NEW SAYERS FOOD STORE

SUBJECT	Addendum No. 2	PROJECT	2102
DATE	September 17, 2021	PAGES	2

ADDENDUM No. 2

DRAWING TITLE
SITE PLAN MECHANICAL

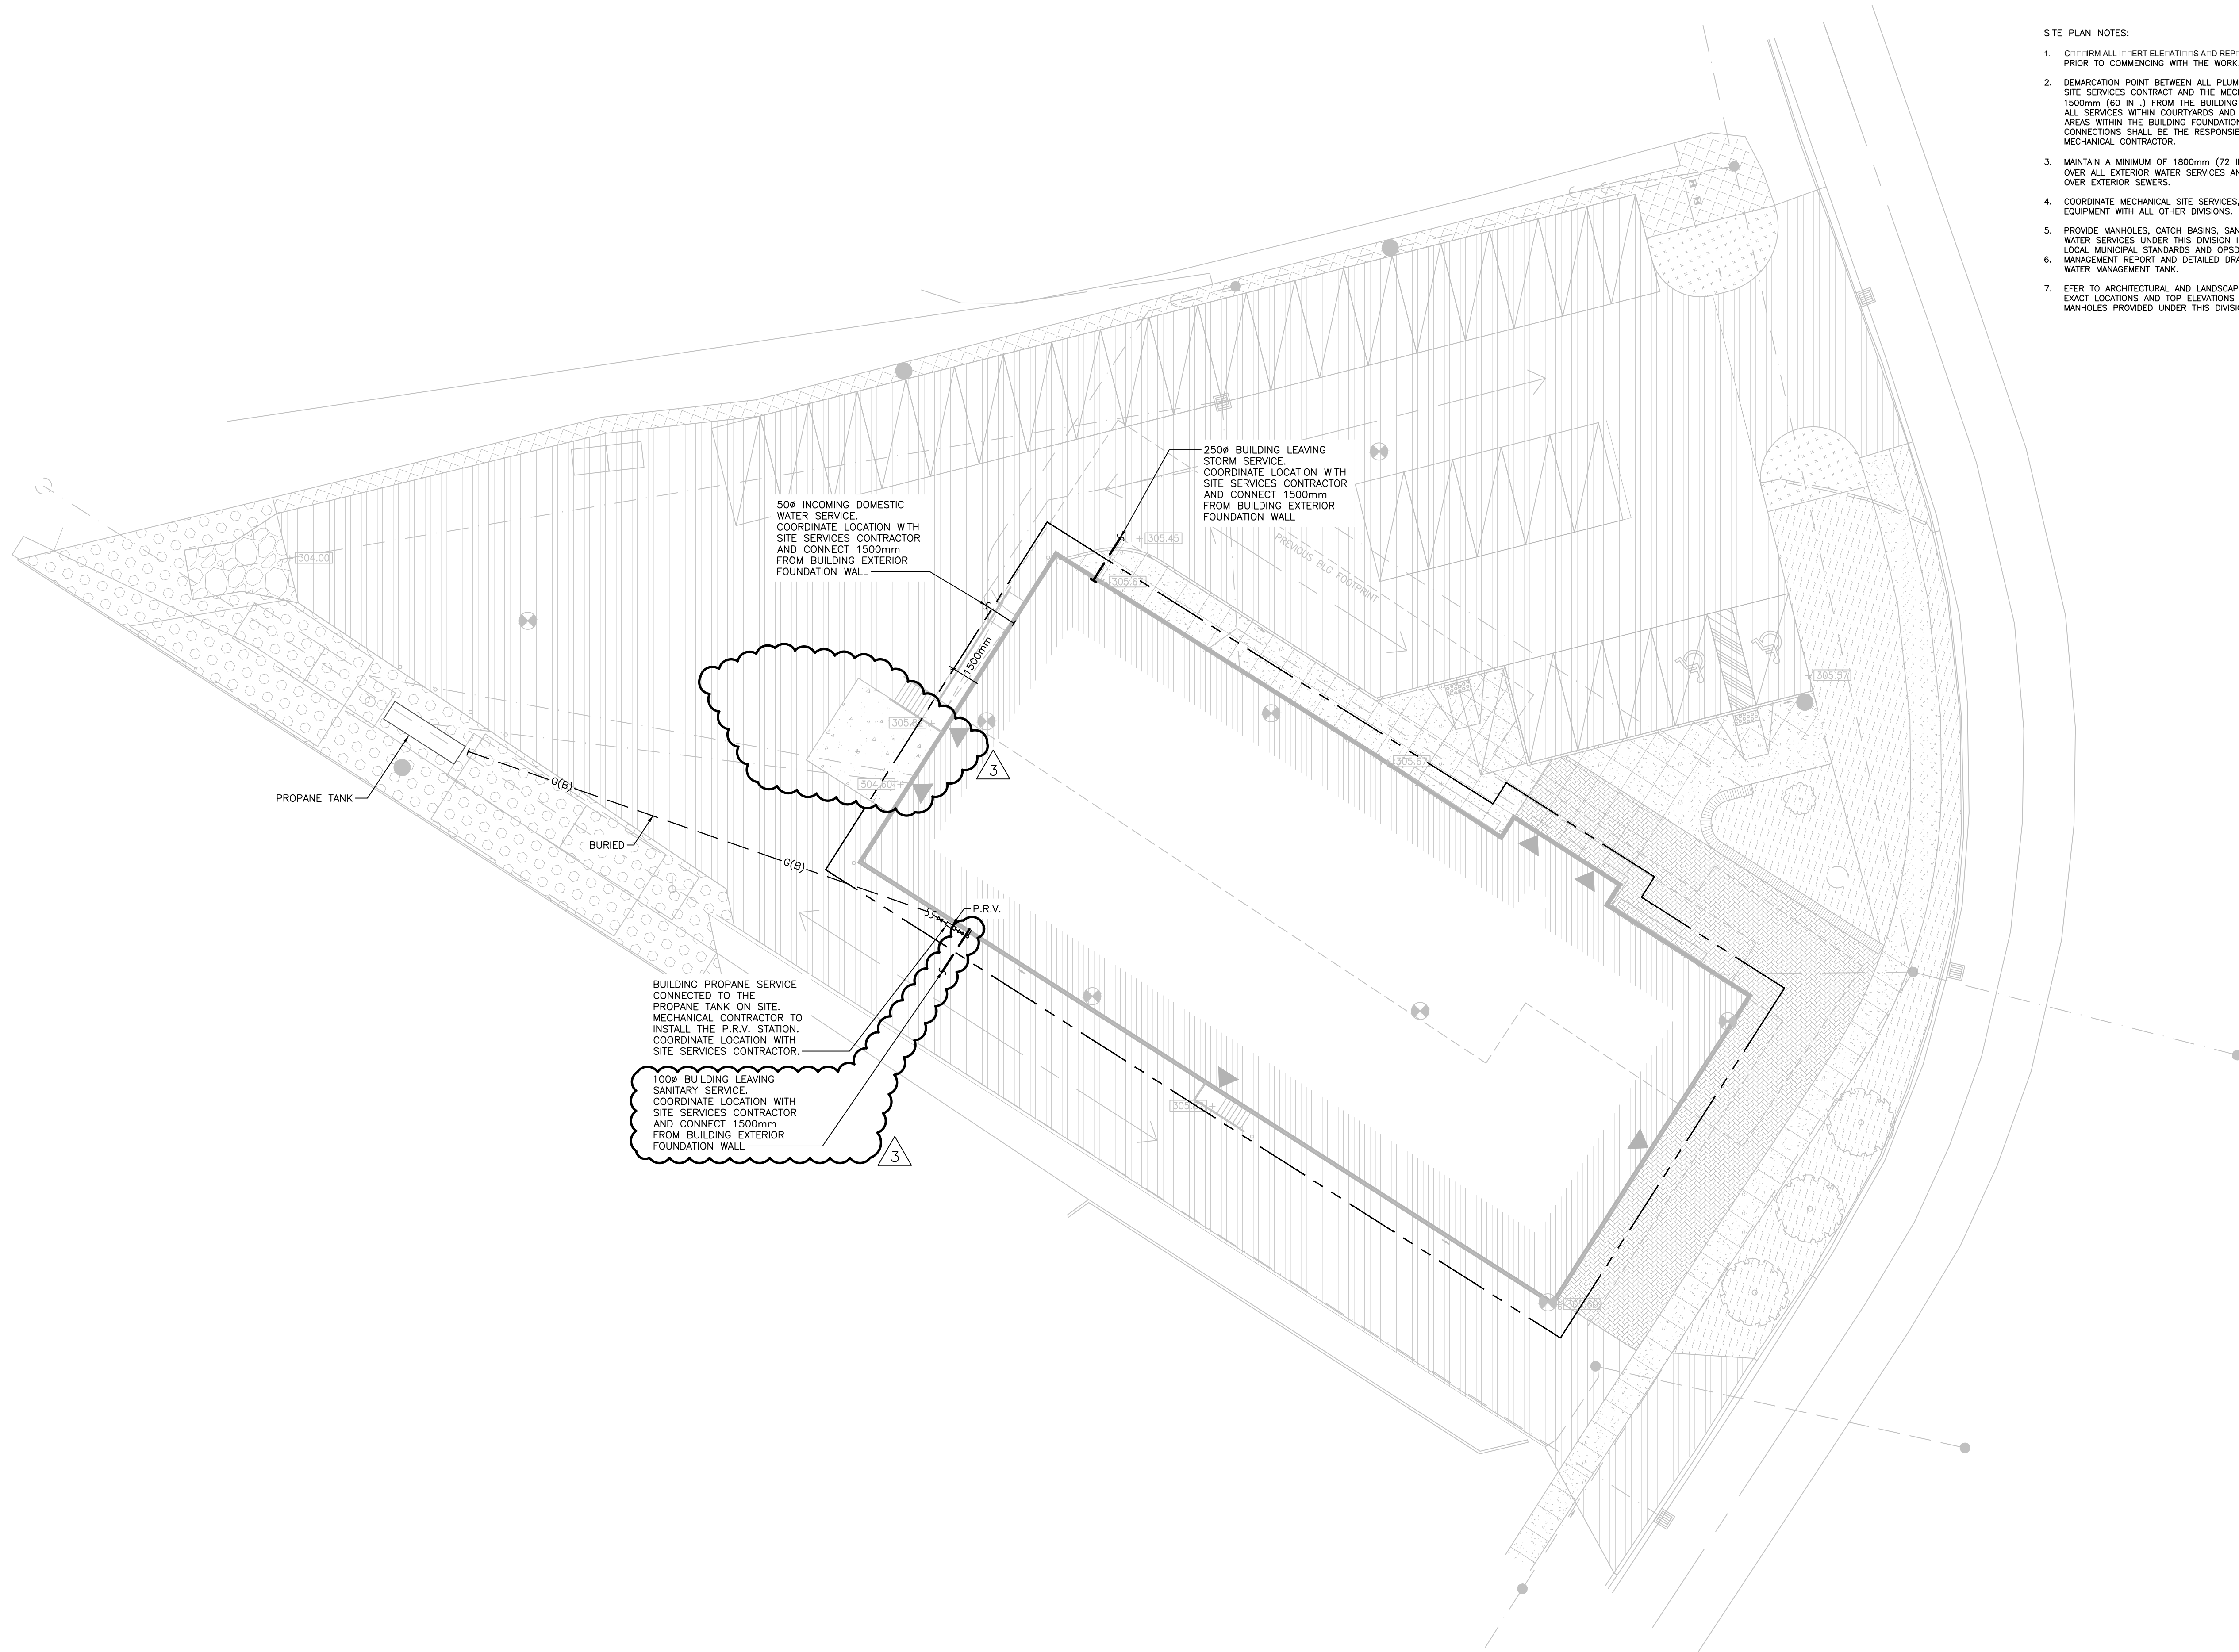
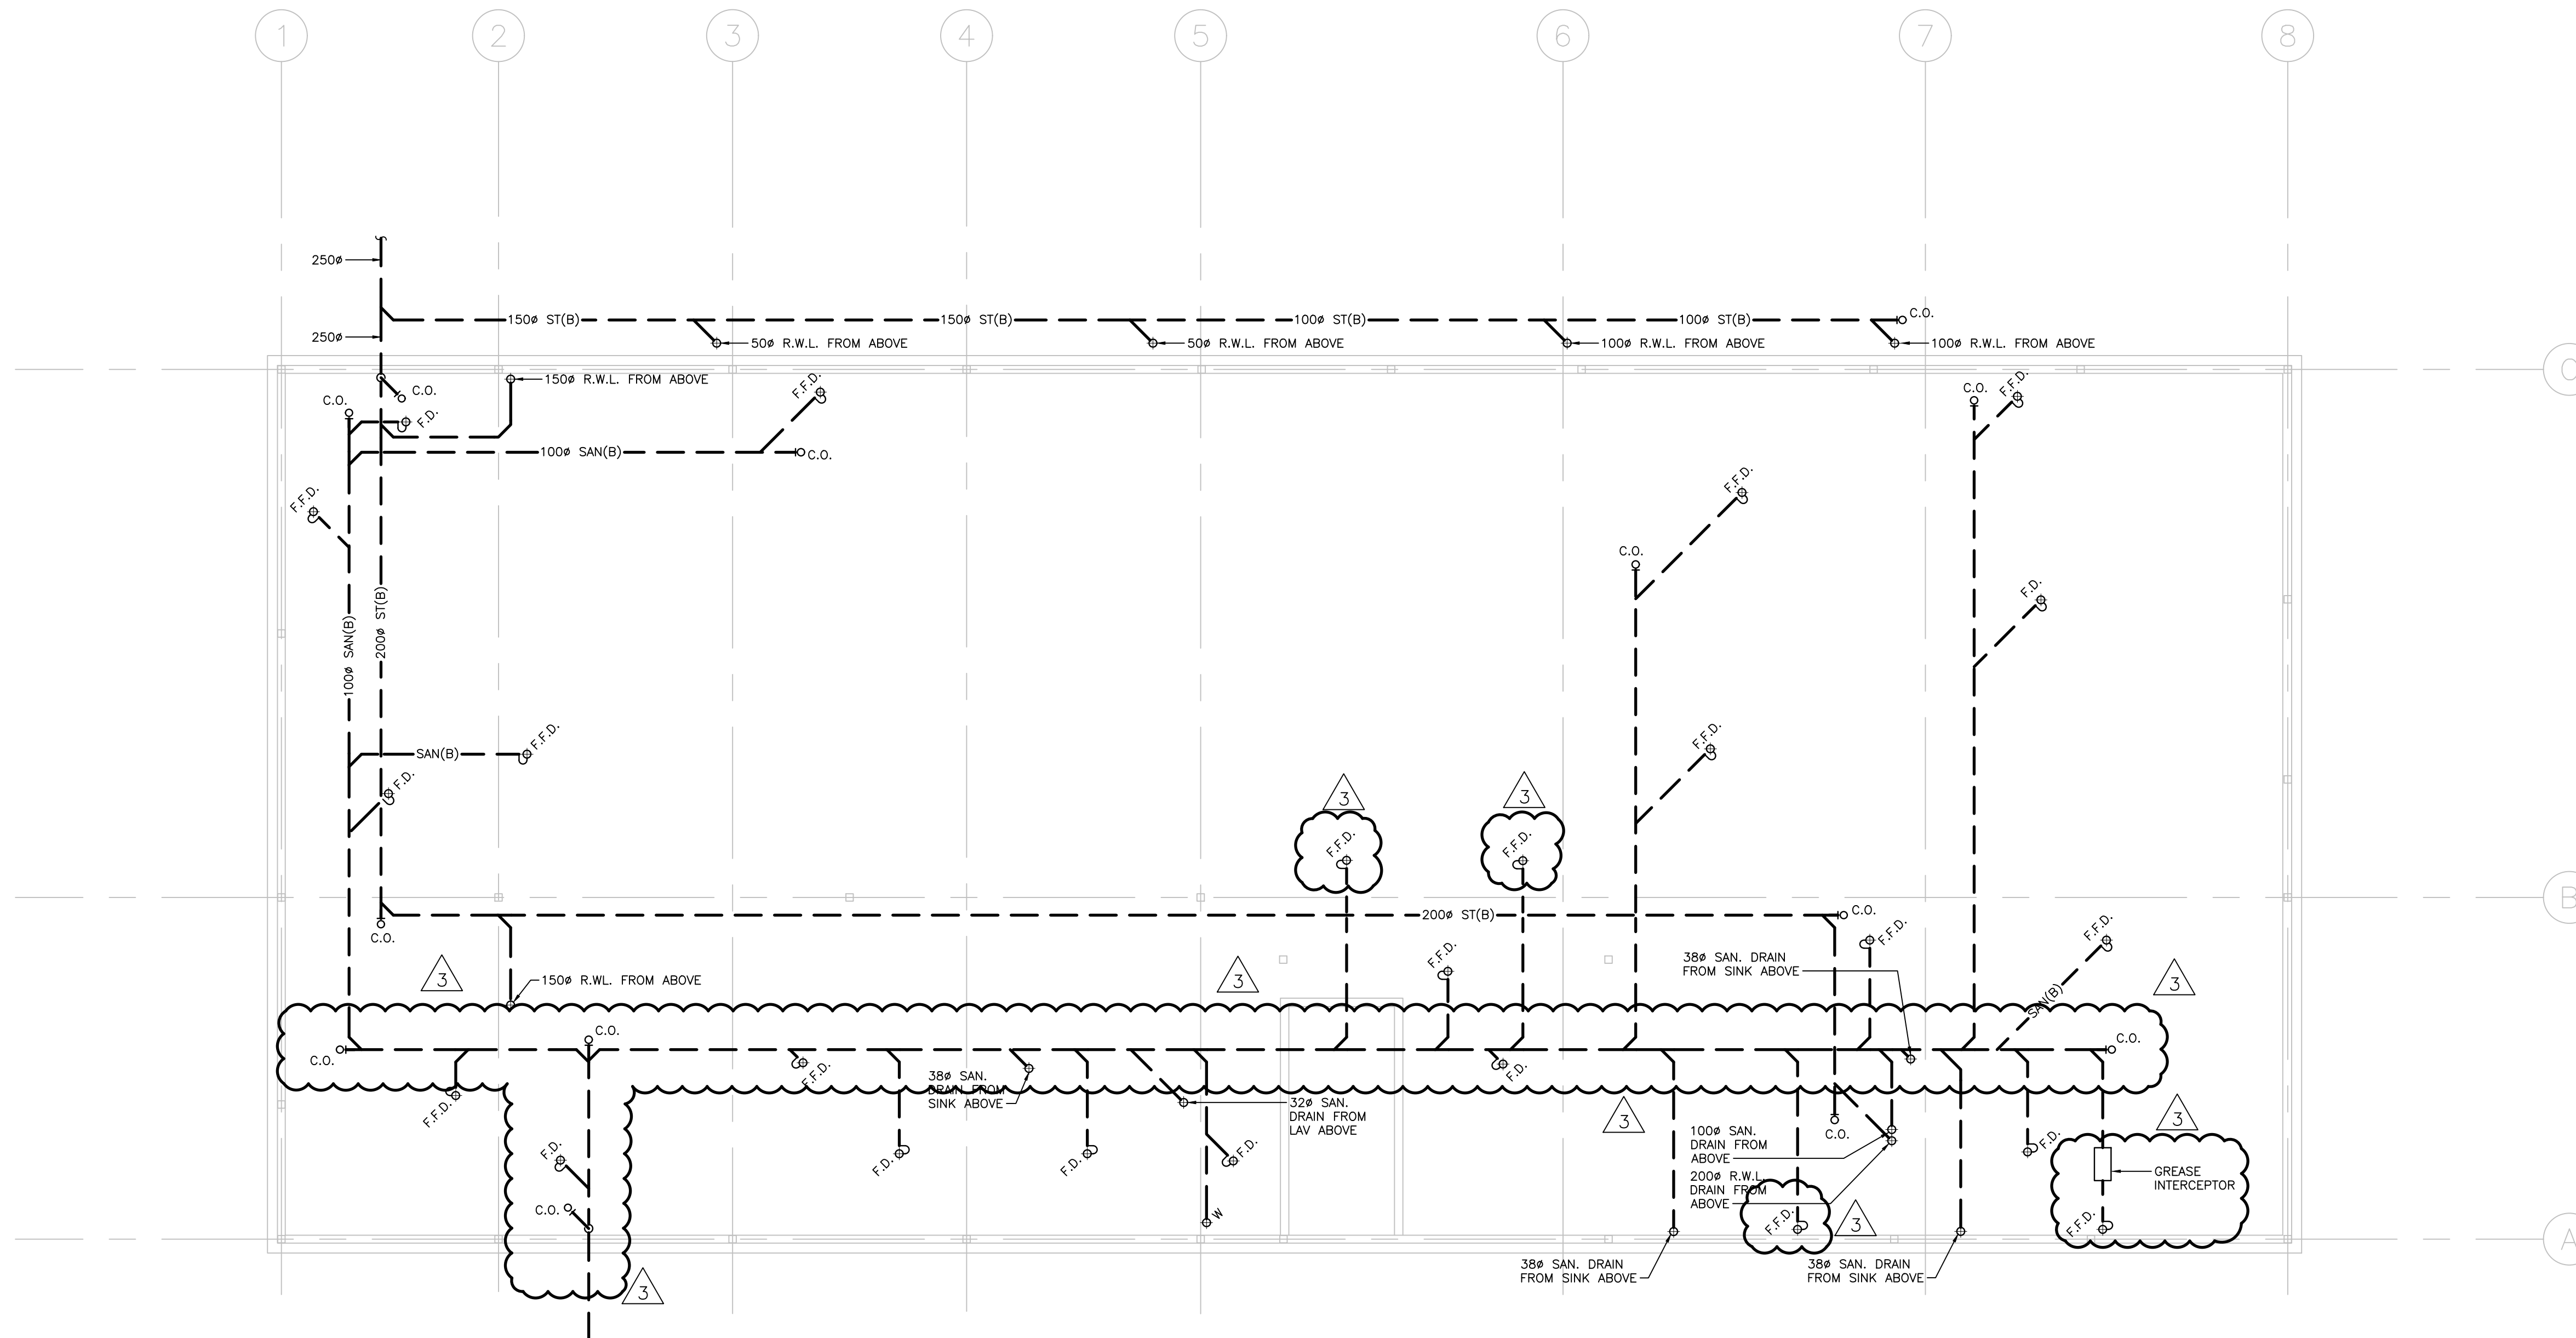
3.1 M100 SITE PLAN MECHANICAL (Re-issued)
